Illinois Power Company

Docket No. 50-461

Subject: Clinton Power Station Unit 1
Humphrey Concerns

The referenced letter addressed some of the John Humphrey concerns as applicable to the Clinton Power Station (CPS). Enclosed are CPS responses on some additional Humphrey issues for NRC Staff review. Included are Action Plans #7, 9, 10, 11, 12, 13, 16, 17, 20, 23, 24, 27, 30, 34, 35, 36 and 37. We believe that these responses will resolve the particular concern involved.

FIGURE 4

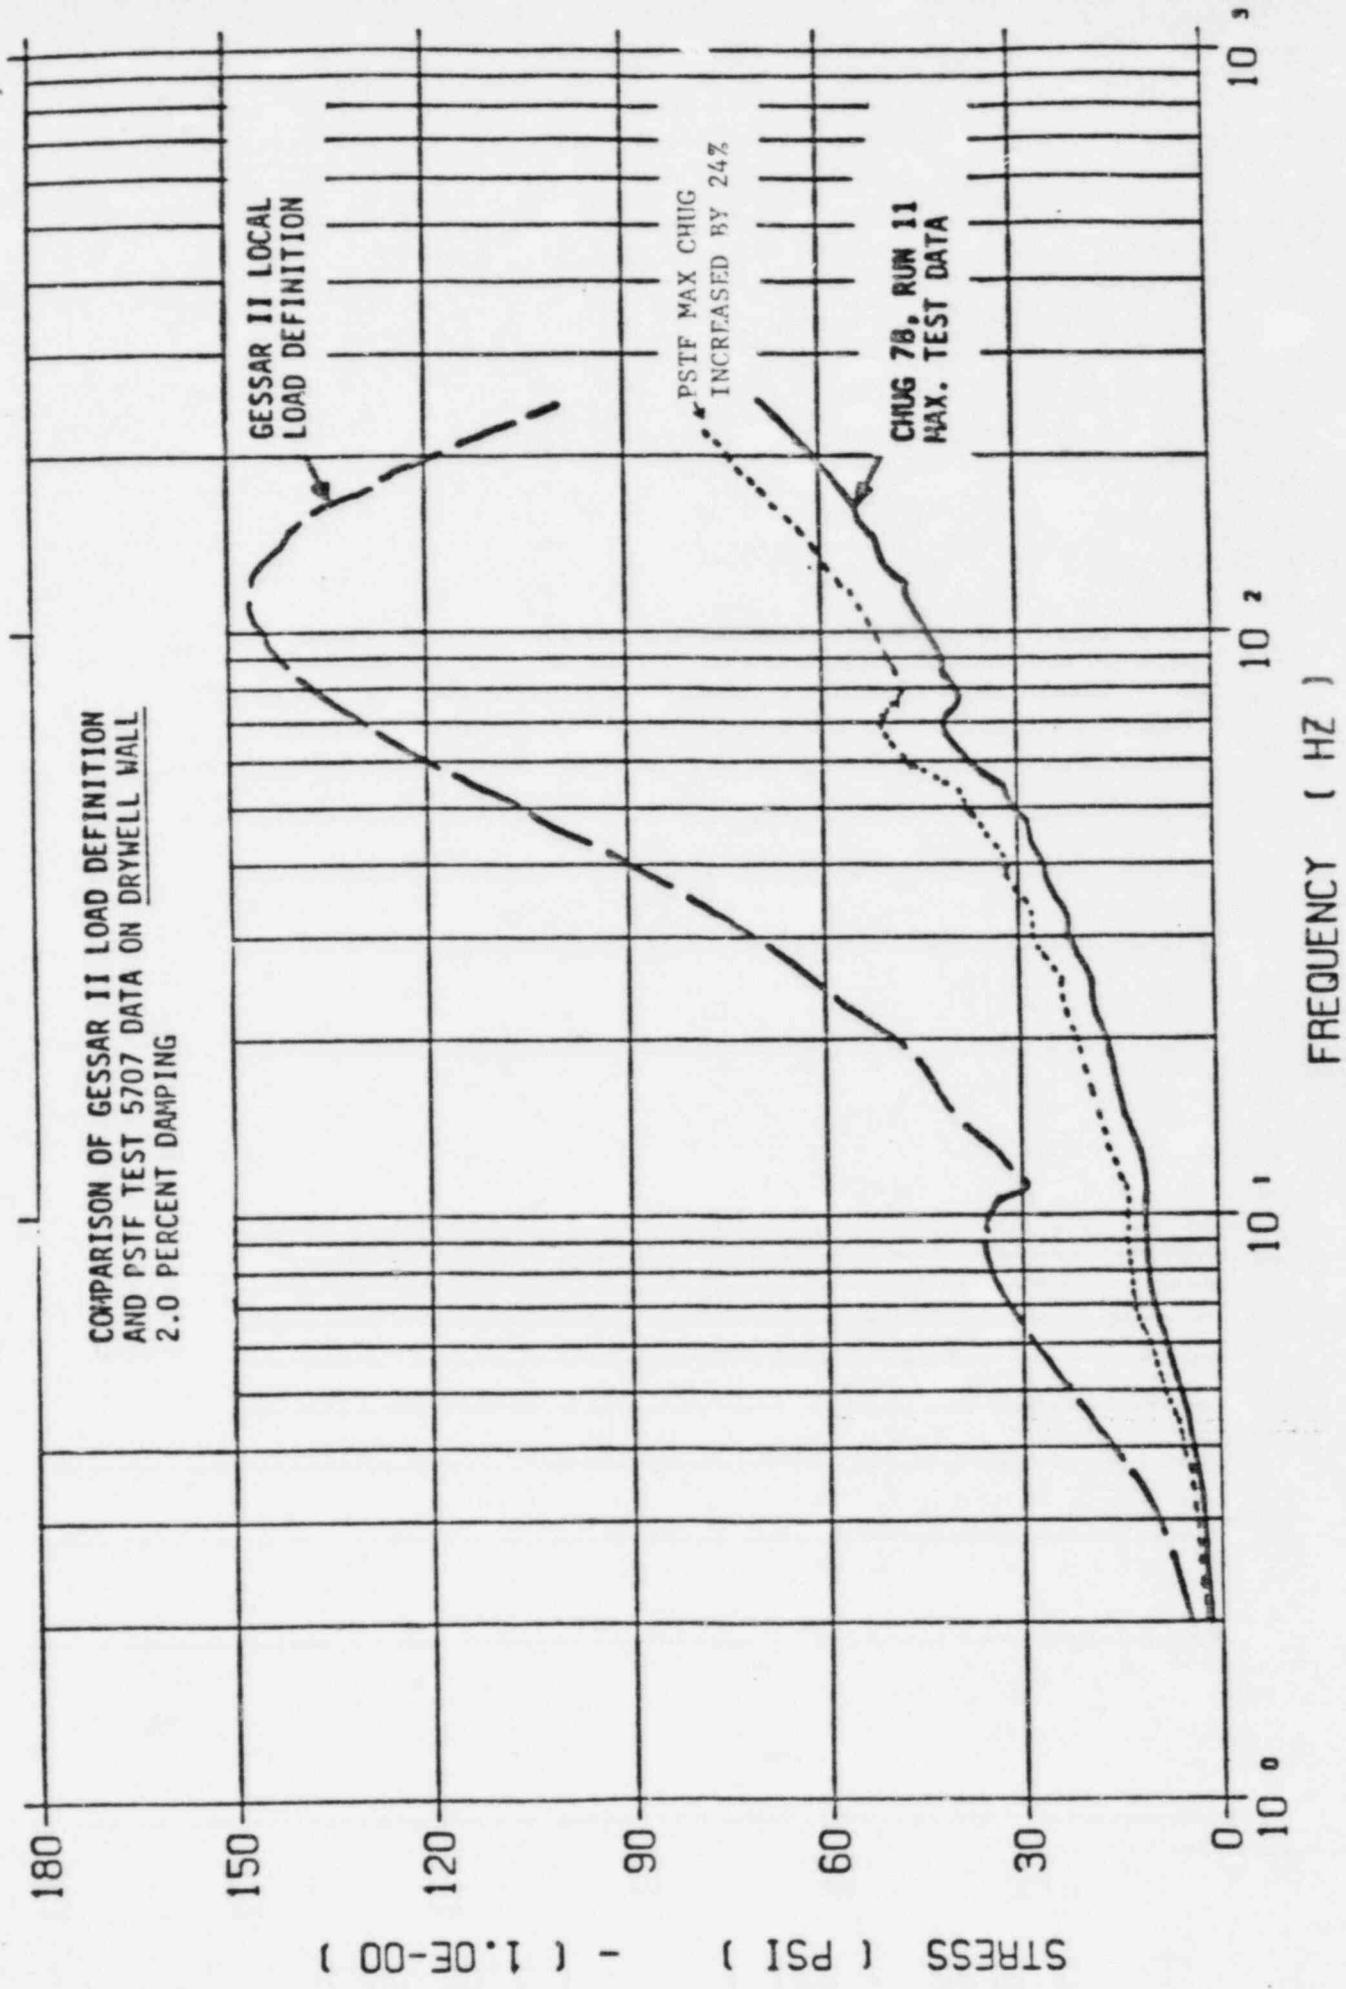
Local load results were then obtained as shown in Figures 4, 5 & 6. The results showed the following:

1. The drywell wall GESSAR II local load definition bounds the increased maximum chug load or the encroached load everywhere as in Figure 4.
2. The containment wall has a slight load exceedance from 15 Hz to 32 Hz; however its energy input is slight compared to the total load energy definition as in Figure 5.
3. The basemat has an exceedance of 35% in the frequency range in Figure 6 to 12 Hz to 22Hz. This load exceedance is not of any consequence since it is a local load and the basemat liner is the structure involved. The hydrostatic head of the suppression pool on the basemat insures that a negative pressure will never be imposed on the liner. In addition, the liner is backed by concrete so that no natural modes of vibration are excitable.

It is thus concluded that the existing local and global load definitions adequately bound increased submergence effects on chugging pressure loads.

Figure 1

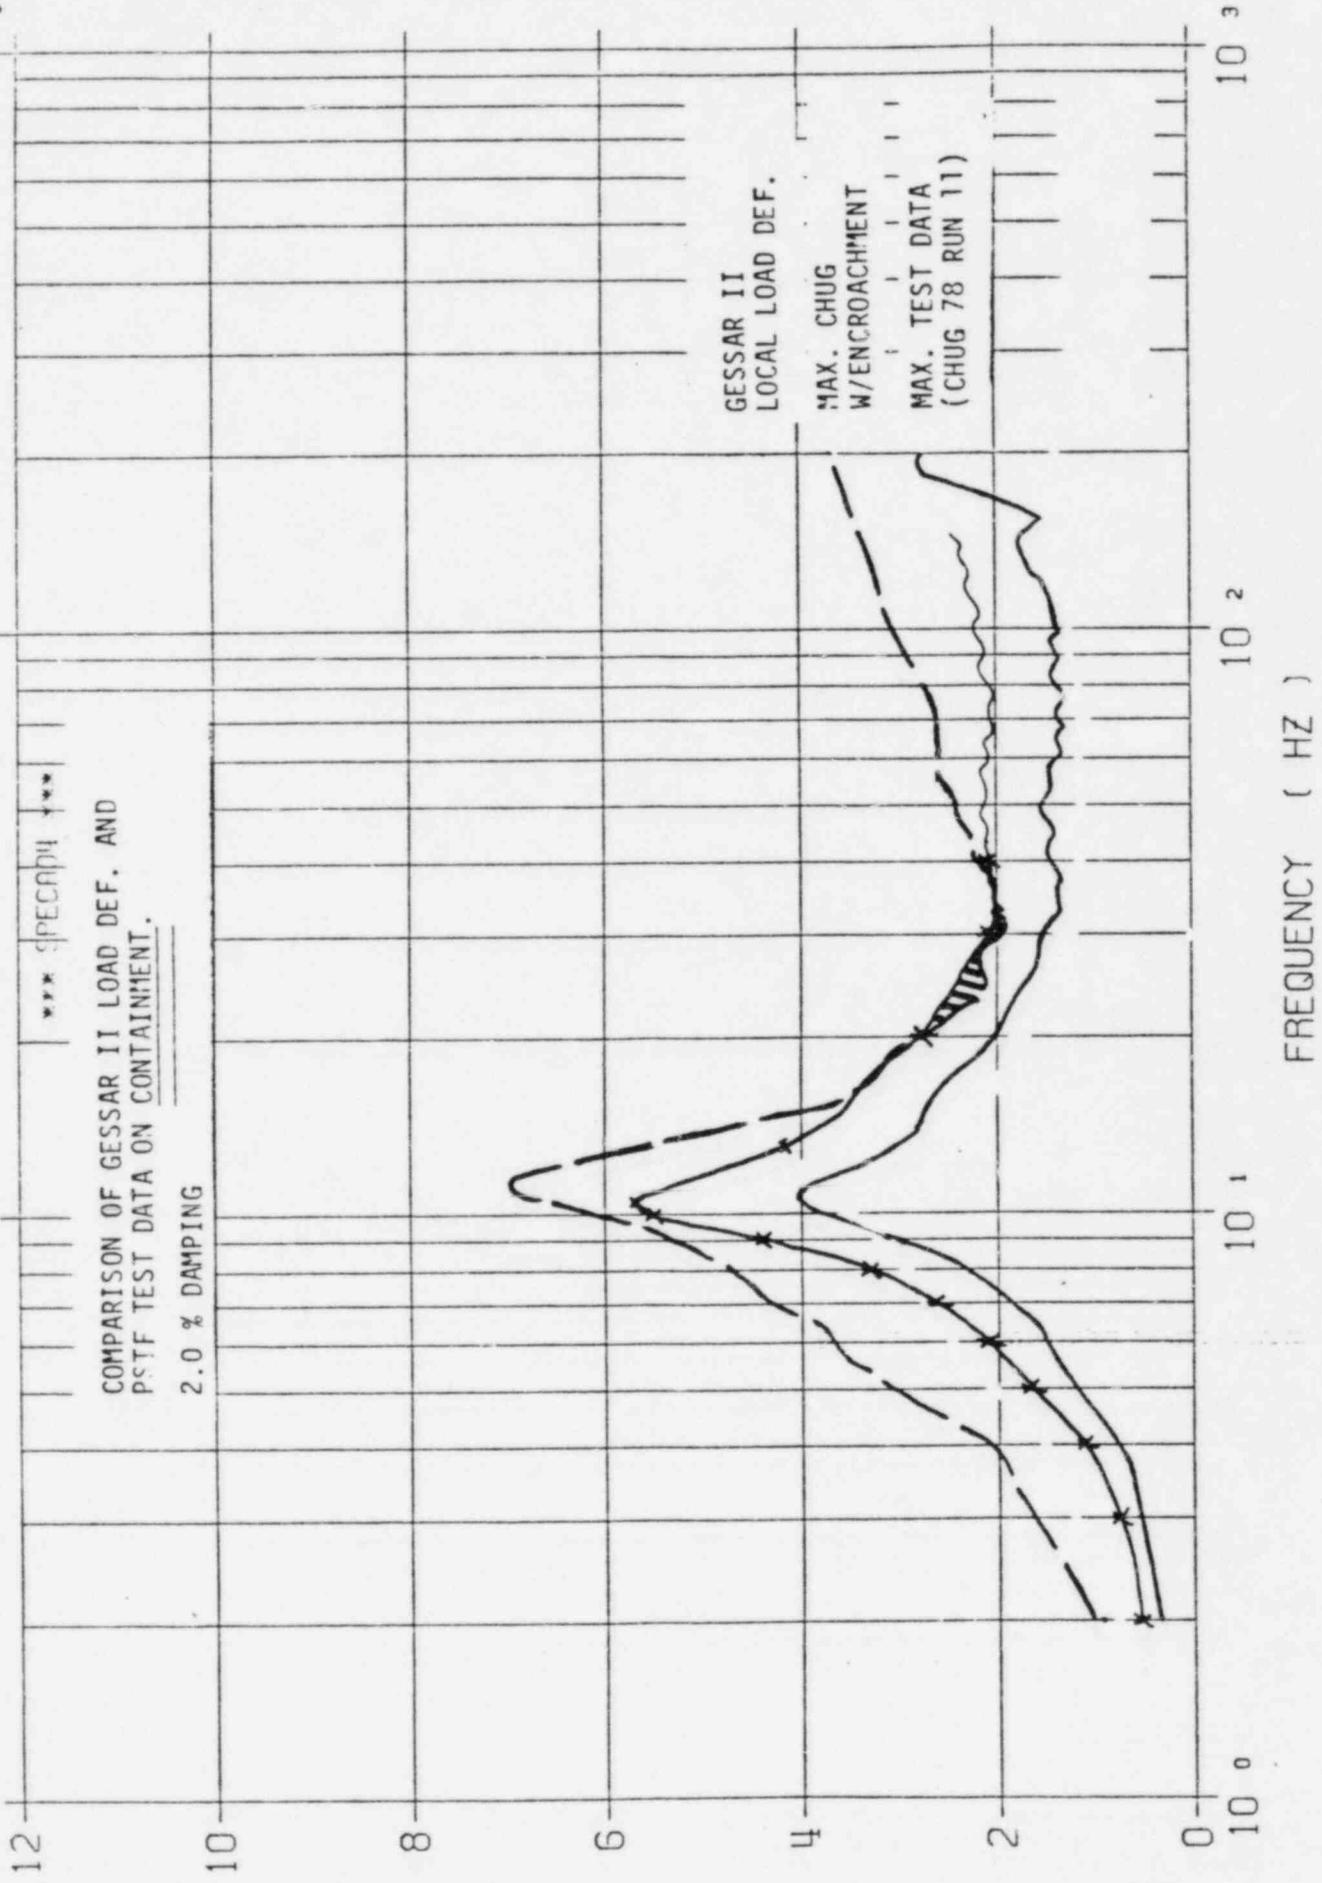
19.2 Effect of local encroachment on chugging.

The effect of local encroachments on chugging loads needs to be addressed.

The above procedure was also performed on the drywell wall and the basemat. Comparison plots are shown in Figures 1 through 3. Figure 1 shows that a small amount of exceedance exists on the containment wall. This exceedance is 15% at its maximum and is judged to be negligible because, as can be seen, the integrated area of exceedance (indicative of energy) is very small in the range of concern. Furthermore, the total load definition energy easily bounds that of the encroached signal energy. Figure 2 shows that the drywell wall load definition bounds the encroached load everywhere. Finally, Figure 3 shows that there is up to 60% exceedance of the basemat local load definition in the frequency range from 12 Hz to 22 Hz.

It is therefore concluded that the existing load definition adequately covers the localized effects of the TIP encroachment.
